Ministry of Public Works
Department of Works and Engineering

Request for Proposals
For
Asphalt Plant Site Works

ADDENDUM 2

Request for Proposals No.: **PN/2024-002-Q-AP**

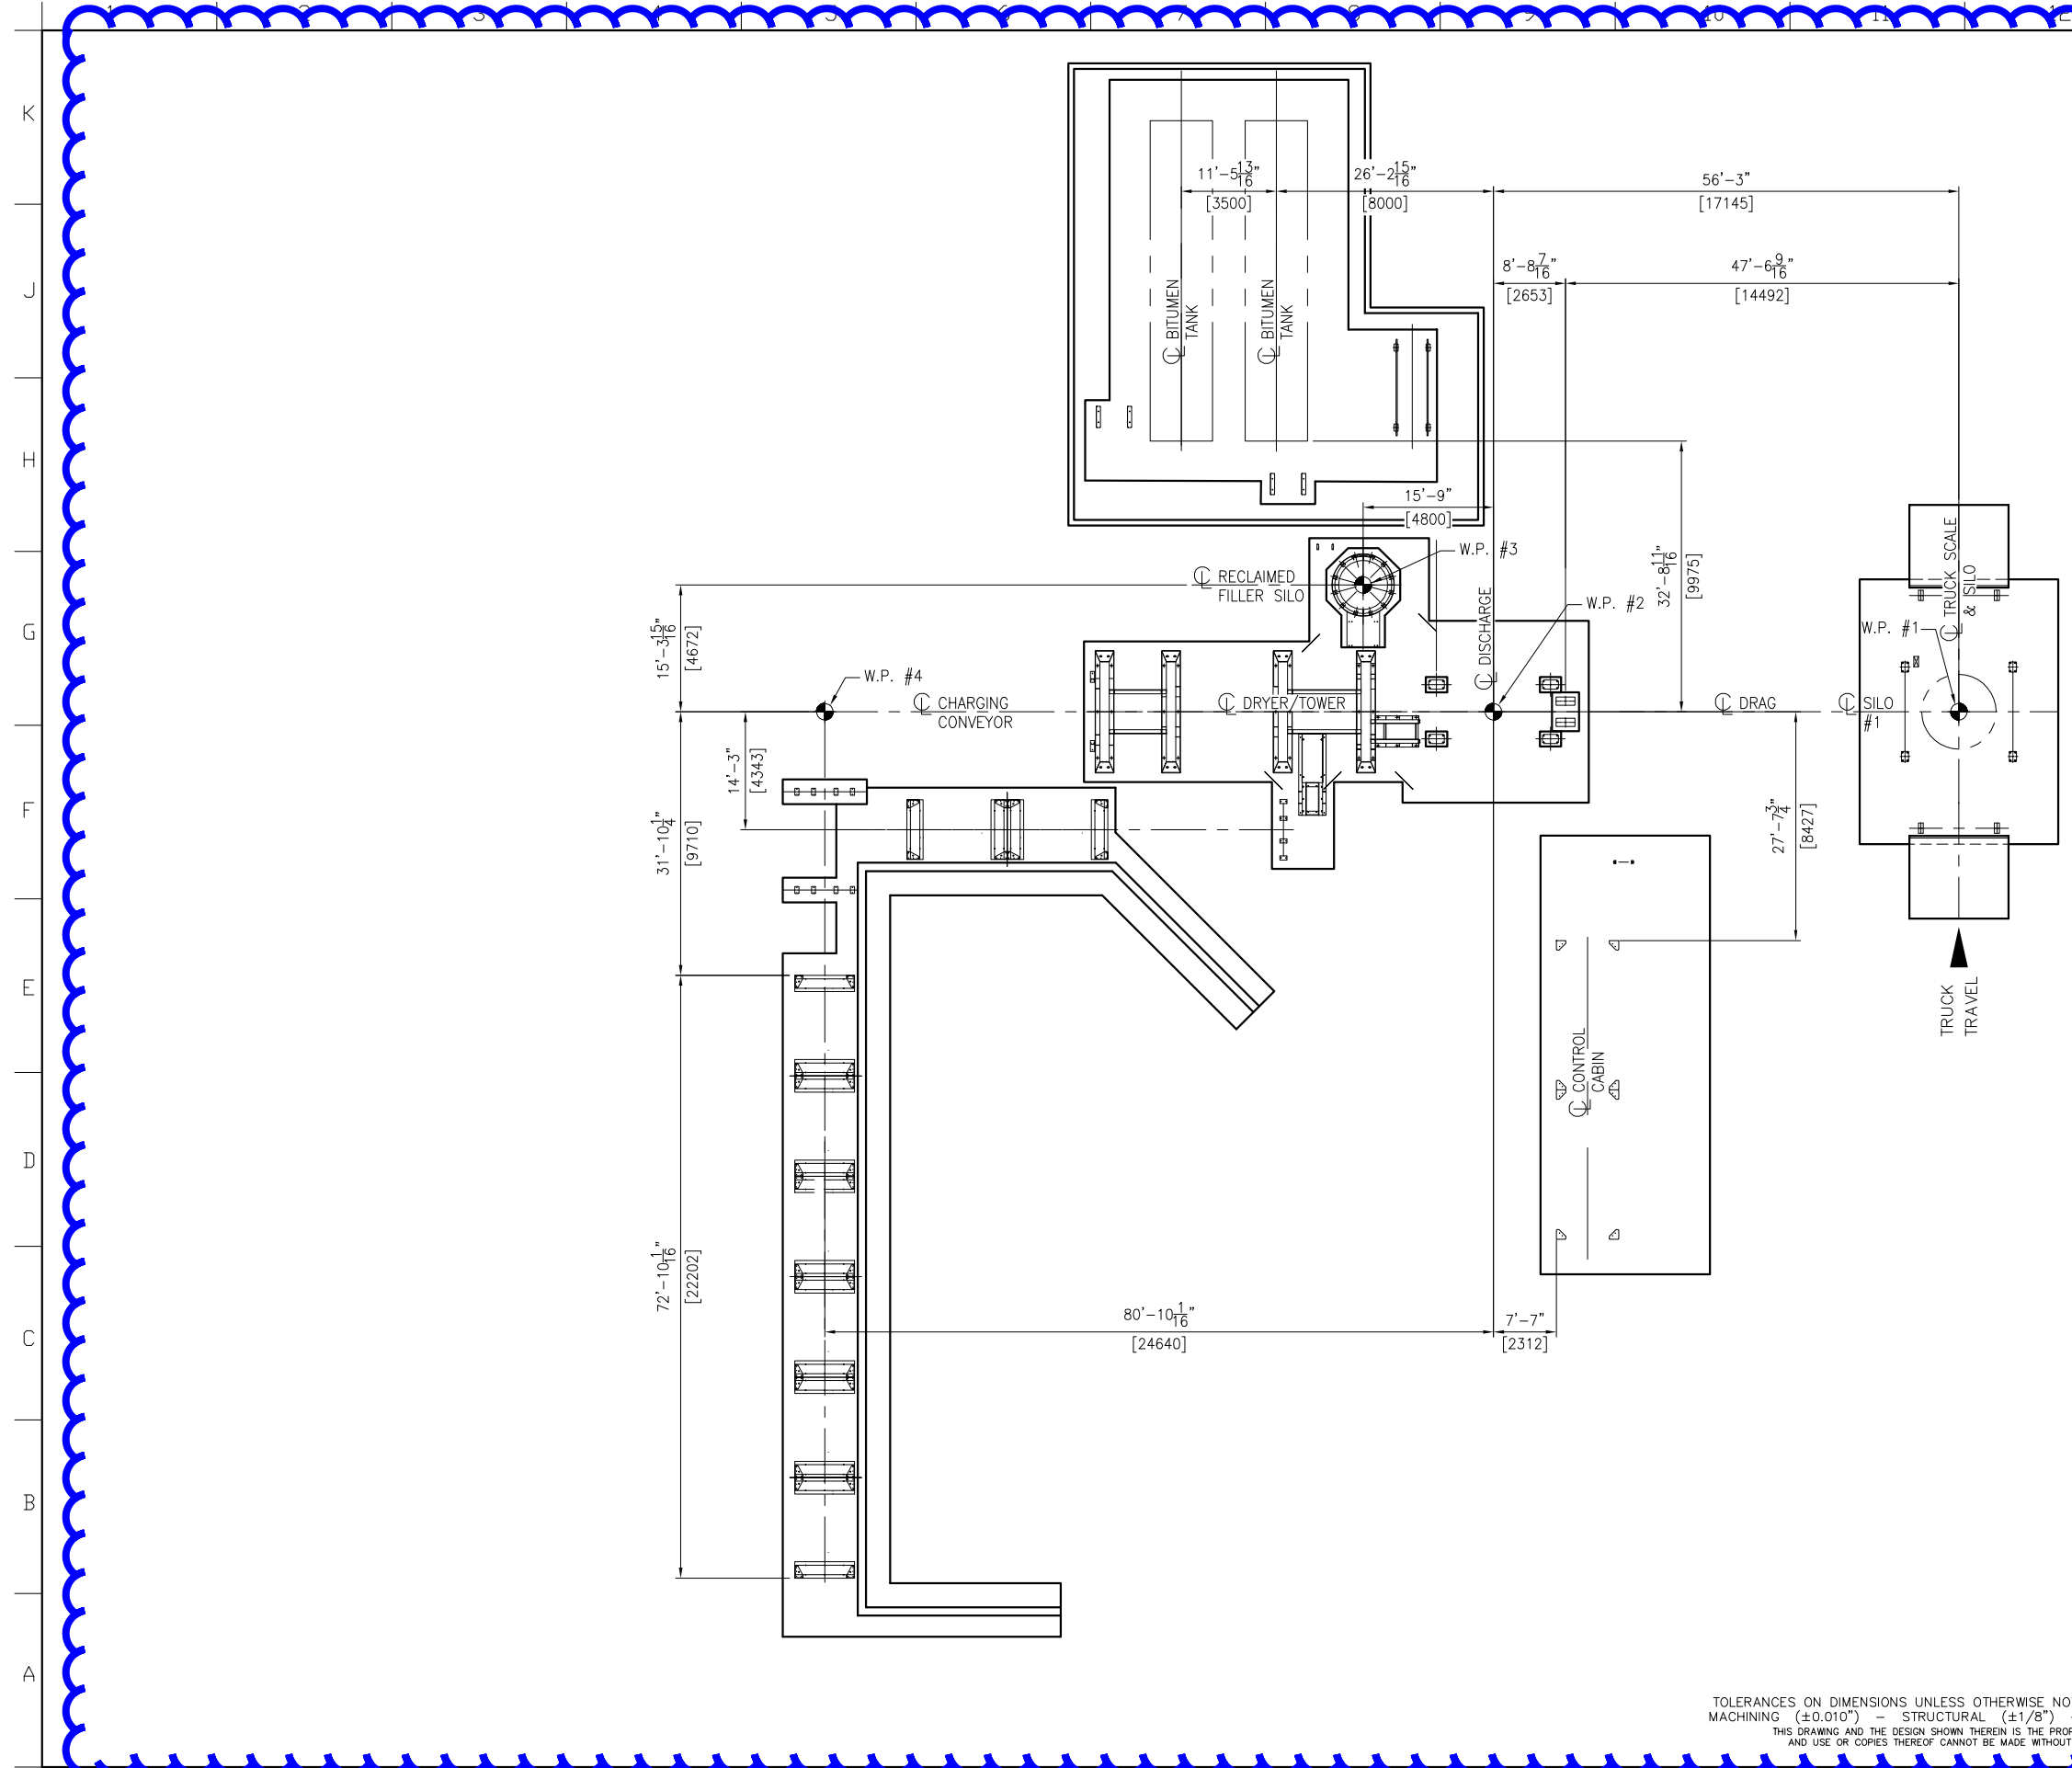
- A4 No borehole work is needed, these are proposed geotechnical borehole locations, by others.
- Q5 Drawing F24-090-01 refers to Details "4" and "5". Could you please clarify which drawing these details are on or other provide these details.

- Q15 Assuming that all WP 2 points for the asphalt plant represent the same point, then the 5'-6" x 5'-6" foundation shown on Astec drawing F24-090-01 clashes with the large dryer tower foundation shown on Astec drawing F24-090-06. Please clarify.

- A5 Additional details are provided in this Addenda.
- Q6 On drawing F24-090-04, please confirm the height of the Wing Retaining Walls.
- A6 Drawings revised, please see drawing F24-090-10.

- A15 Details are included in this Addenda.
- Q16 Please advise whether there is any duty relief on imported materials for this project.
- A16 100% duty free

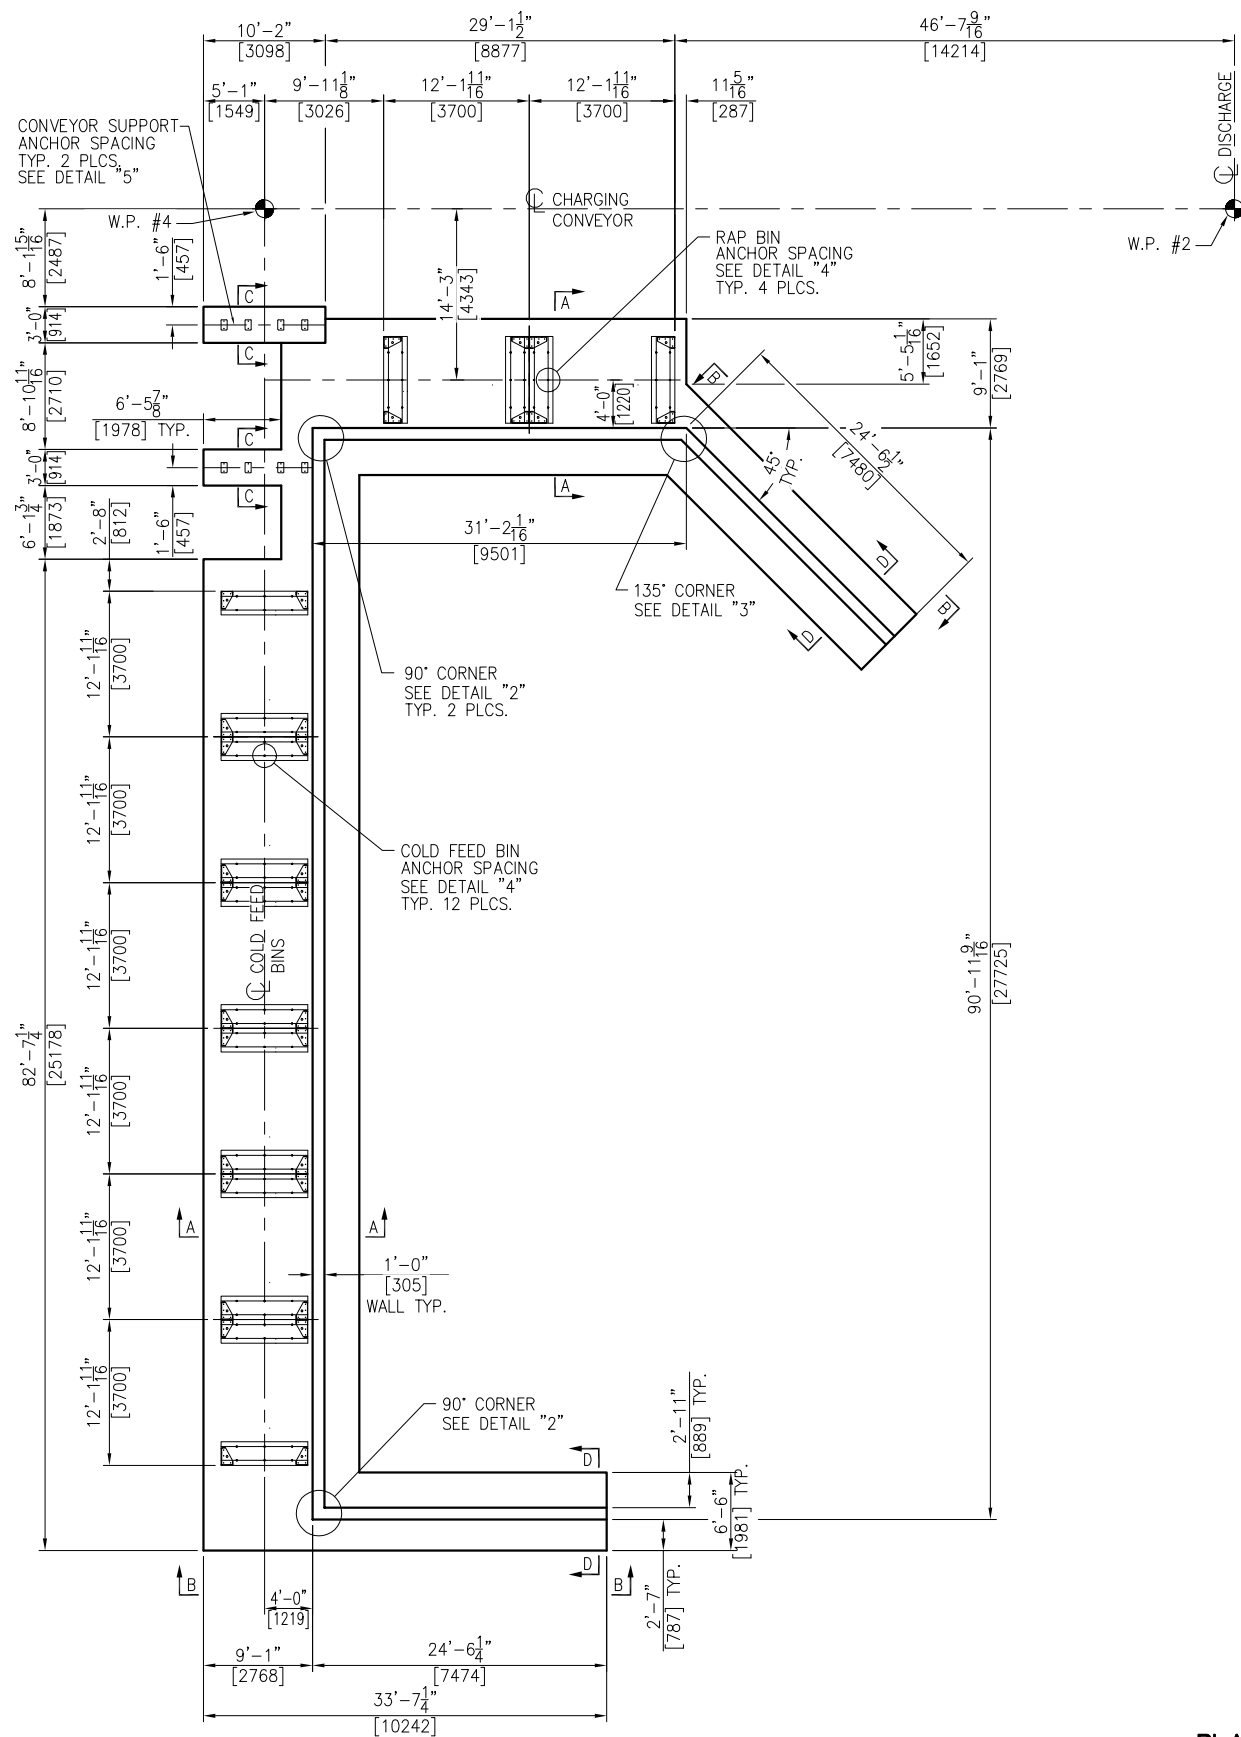
- A11 Top of Concrete will be elev 10'-0" and a benchmark will be provided. Please delete 90ft
- Q12 Astec drawings F24-090-08 and F24-090-09 (pages 26 and 27) note that foundations are to have 12" of granular fill below them, however, the scope document seems to indicate founding on bare rock. Please clarify requirements.

- A12 The area under the footings need to be scrapped to reach bare rock under the existing asphalt, then backfilled to a level where the top of concrete sits at elev 10'-0" +/- as required

MEP1.1

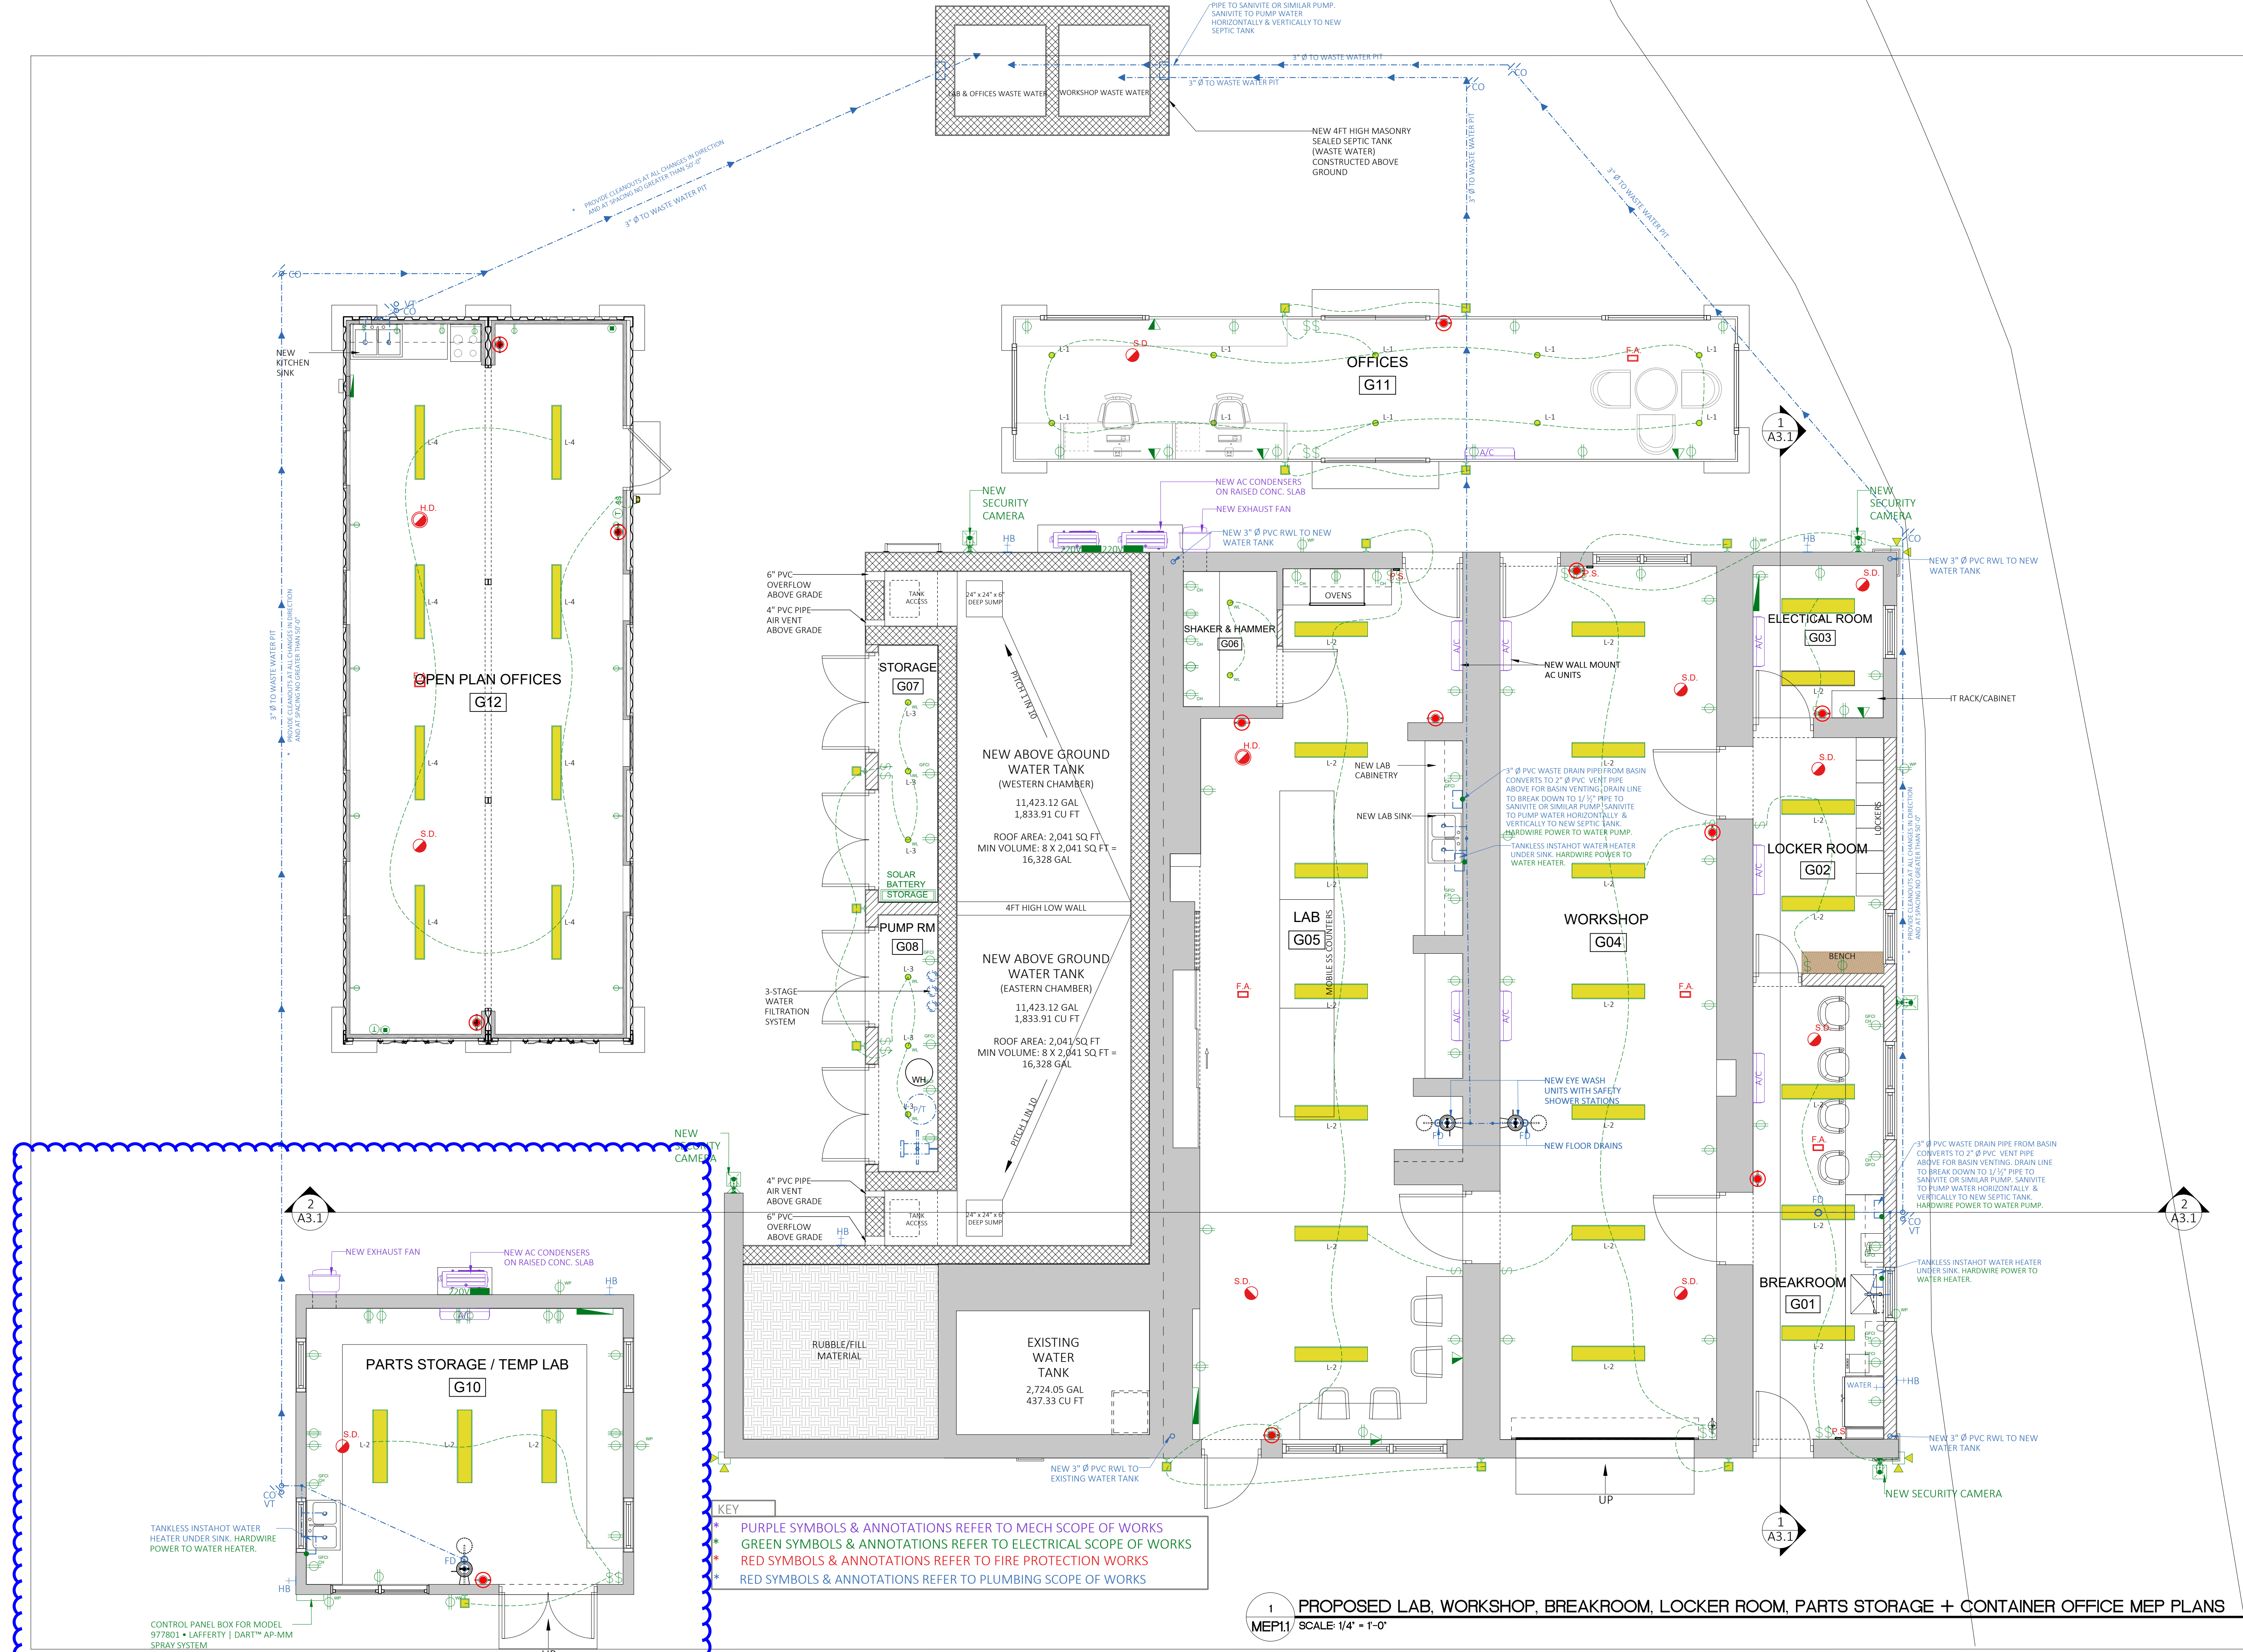
- A21 Not in your scope.
- Q22 With regard to drawing MEP 1.1. Please provide specifications for the mechanical scope, electrical scope, plumbing scope, lighting and fire detection.

- A22 Details are included in this Addenda 1.
- Q23 With regard to drawing MEP 1.1. Is there an electrical panel in this building? Otherwise indicate where the electrical feed is to be taken from.

- Q24 With regard to drawing MEP 1.1. Is there already a water supply to this building? Otherwise indicate where the water feed is to be taken from.
- A24 Details are included in this Addenda 1.
- Q25 With regard to drawing MEP 1.1. Is the fire protection stand alone or is it part of a wider site fire protection system.
- A25 Fire protection is being designed, details to follow.
- Q26 Is the old BELCO vault empty of BELCO equipment, or will there be a need to involve BELCO for equipment isolation and removal.
- A26 It will be empty of all electrical equipment. It has been made dead by BELCO.

- A23 Details are included in this Addenda 1.
